MEMORANDUM

GILL DEVELOPMENTS-CONRICH CROSSING

Subject	Conrich Crossing Subdivision Changes
To	Joey Gill, Gill Developments Paul Douglas, Gill Developments
From	Emily Kloppenburg, B&A
CC	Ken Venner, B&A
Date	April 30, 2024

FIGURE 7 | DEVELOPMENT CONCEPT

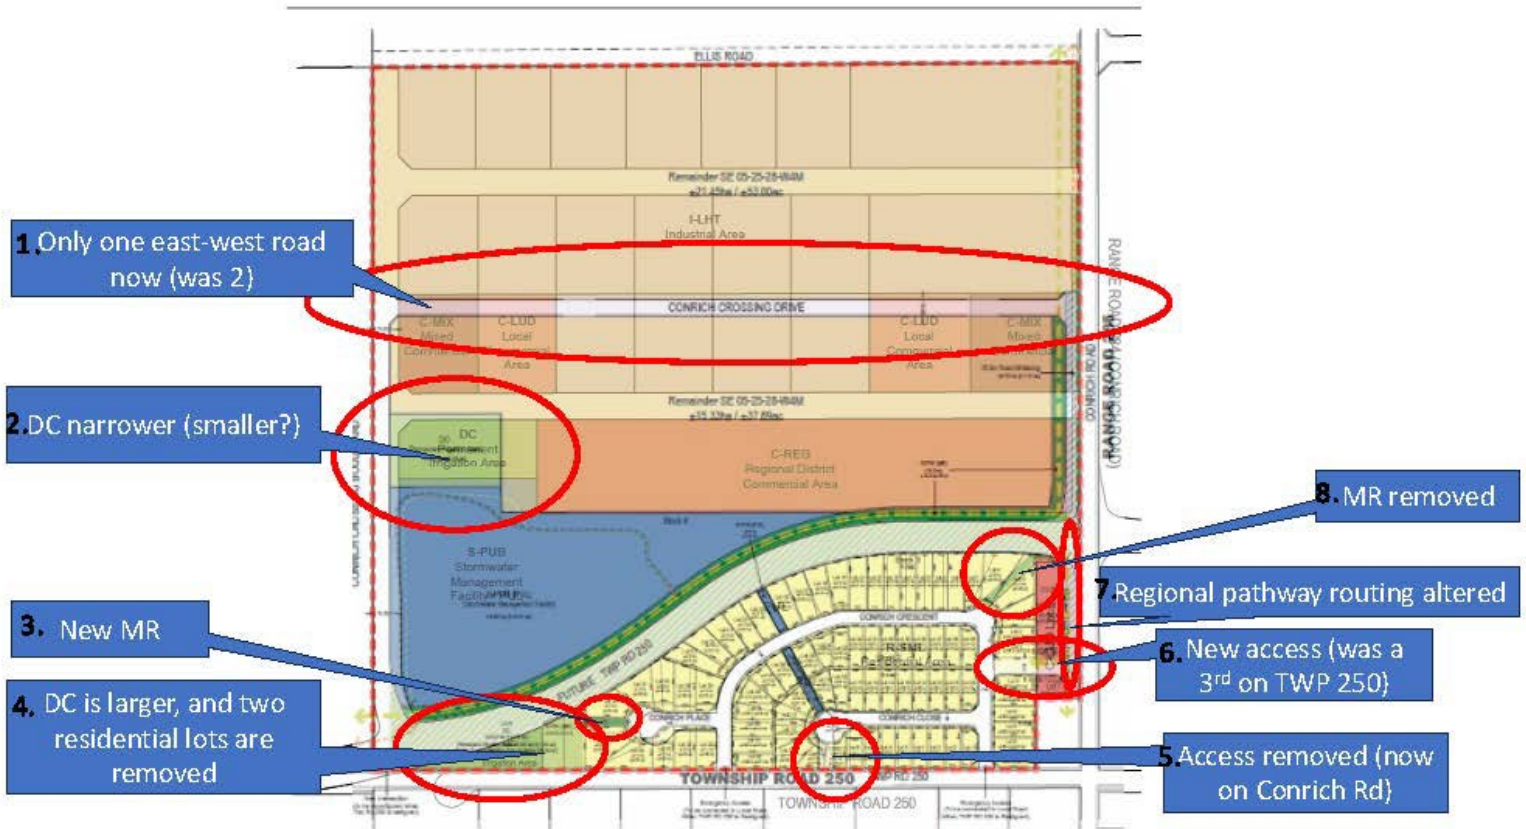
1. Only 1 east-west road now, previously 2

2. DC Irrigation area, narrower (smaller)

3. New MR pathway

4. DC is larger, and two residential lots are removed

5. & 6. Access removed (now on Conrich Rd) & New Access (was a 3rd on TWP 250)

7. Regional Pathway routing altered

8. MR removed

The revised TIA produced by Bunt & Associates and submitted to the County in December 2023 notes, “the previous Conrich Crossing Phase 1 TIA included two future roads located north of the new Township Road 250 to provide a temporary alternate route to the adjacent lands. This was required to address the difficulties with truck movements at the existing Township Road 250 / Range Road 284. However, with the realignment of Township Road

250 occurring in 2025 (based on information provided by RVC), the construction of these roads is no-longer needed for a temporary alternate route. While these roads are still included in the tentative plan for this phase, they will not be constructed until a future phase.”

There is still an east-west connection that is provided for in this subdivision application, with a potential future extension of Ellis Road that could further facilitate east to west movements. The proposed location of this east-west connection is based on intersection spacing requirements to ensure adequate separation from the intersection of the proposed realigned Township Road 250 and Range Road 284.

Further, the current subdivision application does not require the proposed Conrich Crossing Drive for access or utility servicing. It was included when there was less certainty as to the timing of the Township Road 250 realignment. As it is not needed, construction of this connection can be deferred to a later phase if the realignment of Township Road 250 proceeds as planned.

The shape of the north DC Irrigation Area has been revised to accommodate changes to the site plan which have included shifting Conrich Crossing Drive northward. The total area of the north DC Irrigation area has increased from 1.04 ha (2.57 ac) as shown in the Conceptual Scheme to 1.05 ha (2.60 ac) in the subdivision applications. It is the expectation that formalization of utility areas, such as the one contemplated by this DC district, is done at the subdivision stage. As such, the applicant does not believe that there has been enough change to the function of this parcel to warrant a land use amendment.

This pathway was added based on discussions with the County’s Recreation, Parks and Community Support and Planning teams as a part of this subdivision application. Recent comments from the Recreation department include:

The applicant’s understanding was that this was an acceptable solution that satisfied the County’s desire to see a pedestrian connection between the residential area and the DC Irrigation Area that the applicant is proposing as a programmable open space amenity. The primary purpose of the DC area is for the irrigation of stormwater; however, the area can be used for outdoor recreation provided that there is no conflict between the primary irrigation purpose and the recreational use. No objections have been noted from Recreation, Parks and Community Support regarding this MR pathway or the proposed recreational use.

Access to these two residential lots could only be provided from Township Road 250 and they could not be well integrated into the rest of the plan area. By removing these lots, the applicant was able to increase the DC Irrigation Area. As discussed with Recreation, Parks and Community Support, this additional DC Irrigation Area could be used as programmable open space in line with the Recreation team’s comments as noted above.

Conrich Road continues to operate as a major truck and goods movement corridor. Providing access to a residential subdivision from this type of road is generally not preferred. Since the realignment of Township Road 250 will divert traffic off Conrich Road, where the entrance to the residential subdivision will be located, it was determined that this entrance would provide better connectivity to the residential subdivision.

The current plan is to cut off the existing Township Road 250 once it is realigned. Having all three access points located onto a dead-end road would pose serious challenges for emergency services accessing the residential subdivision should there be any impediment or blockage at the intersection of Township Road 250 and Range Road 284. Prompted by these safety discussions with the County, the primary access was relocated to Range Road 284 with the remaining access points onto Township Road 250 as Emergency Access roads as per the Conrich Crossing Conceptual Scheme. Policy 3.3.2.6 of the Conrich Crossing Conceptual Scheme notes "The provision of emergency/secondary access to Township Road 250 from the residential area in Phase 1 shall be confirmed at subdivision stage and considered against municipal standards."

Furthermore, the revised TIA produced by Bunt & Associates and submitted in support of the subdivision application in December 2023, illustrates that access to the residential subdivision will be provided "with one connecting to Range Road 284, and two additional accesses connecting to the segment of the existing Township Road 250." It is the applicant's understanding that since no further comments have been received regarding the findings of the TIA that they meet the County's standards for access and have been accepted.

The alignment of the regional pathway has been previously addressed through a Land Use Amendment Application submitted in October 2022. The alignment of the Regional Pathway along Conrich Road has been discussed with the Planning and Engineering teams at RVC and has evolved through conversations in the fall and winter of 2023. Our plan to accommodate the Regional Pathway will require ongoing conversations with RVC but has so far been based on recent traffic studies, draft changes to the Conrich ASP and the expedited timeline for the realignment of Township Road 250. Recent cross sections of Conrich Road that include the proposed Regional Pathway were submitted for review on March 27, 2024.

A similar comment was addressed as a part of the previous 2022 subdivision application with the response provided below. This was addressed through a Land Use Amendment application that was submitted in October 2022. The status of this application is unconfirmed.

From more recent conversations with the Recreation, Parks and Community Support team, the applicant understands that pedestrian connectivity between the regional pathway and open spaces is important to the residential subdivision and the larger community. The proposed pathway alignment achieves this goal by providing the connectivity in a safer and more accessible location.
